Dane County Planning & Development

Land Division Review

Re: Certified Survey Map – Josh & Rebecca Eastmead
Town of Burke, Section 3

DANE COUNTY CERTIFIED SURVEY MAP NO. _____

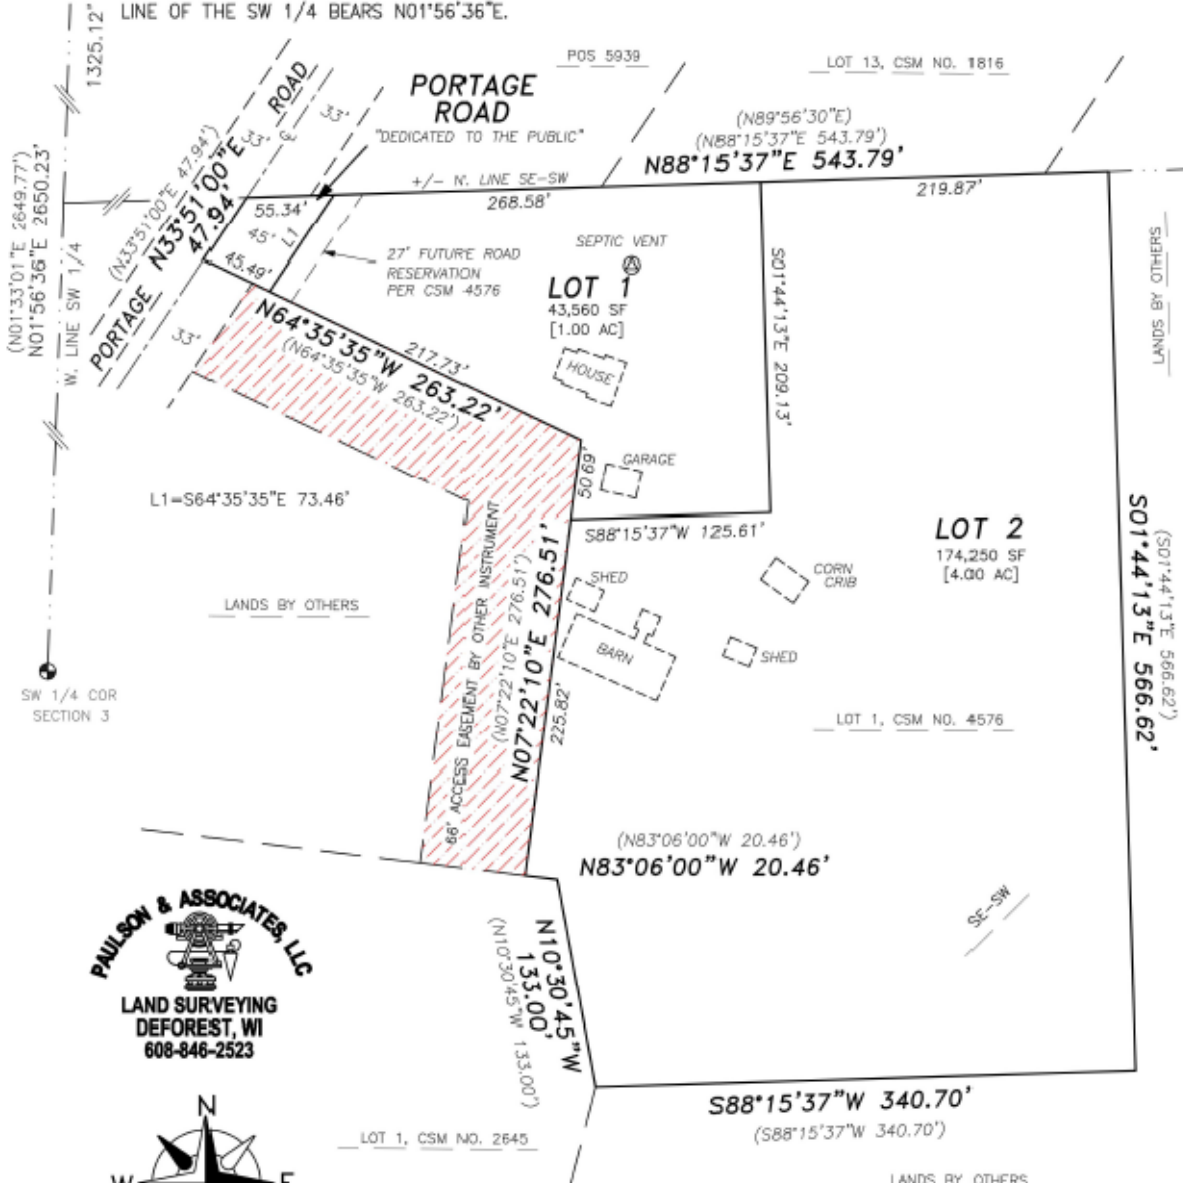
The new proposal shows Lot 1 having all the frontage and Lot 2 having no frontage. Access to the new Lot 2 is through a new 66-foot shared access easement mapped on an adjacent lot under the ownership of Frances Hoffman.

STAFF RECOMMENDATION: In summary, the shared access easement provisions found within Ch. 75, does allow for lots to be created with no public road frontage as long as one of the proposed lots has 66 feet of frontage. This proposal does not meet those standards.

Planning staff recommends that if the 66-foot shared access easement is to be located on an adjacent lot, then that lot should be included within the new Certified Survey Map and the provisions of 75.19(8) met.

75.19(8)(d) - If two or more lots are proposed to be served by a shared driveway easement, including the lot on which the easement is located, at least one of the lots must have a minimum of 66 feet of frontage connecting directly onto a public street at a location where the driveway shall be constructed.
